Transmitted by the expert from IMMA

Proposal for amendment to GRE/2012/15. IMMA proposal for collective amendments to Regulations Nos. 53 and 113 on bend lighting for motorcycles

Figure: Vehicle bank angle at the time the motorcycle takes off

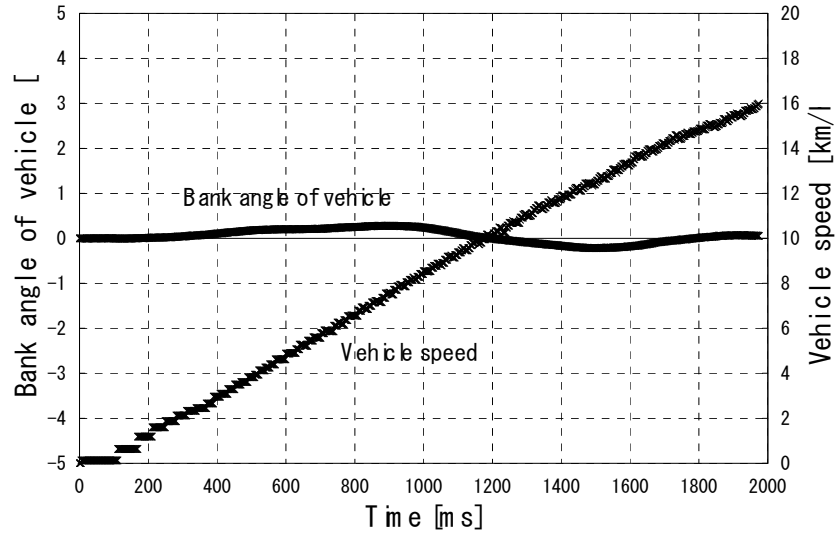
The bottom figure illustrates the bank angle of motorcycles measured under the following conditions.

Test conditions
- Test vehicle 400ml-class scooter
- Load 2 passengers

Measurements were taken immediately after the vehicle took off when it is the most unstable, in addition to the following conditions, in which "wobbling" by a motorcycle was thought to be the greatest.

From the results, it is clear that the bank angle of a motorcycle when it is running at low speed is small enough so that it is appropriate to add the "less than 5 degrees" as a prohibitive condition, in order to prohibit the unintended use of bend lighting.

"6.2.6.1. However, the additional light source(s) or additional lighting unit(s) shall not be activated when the bank angle is less than 5 3 degrees."
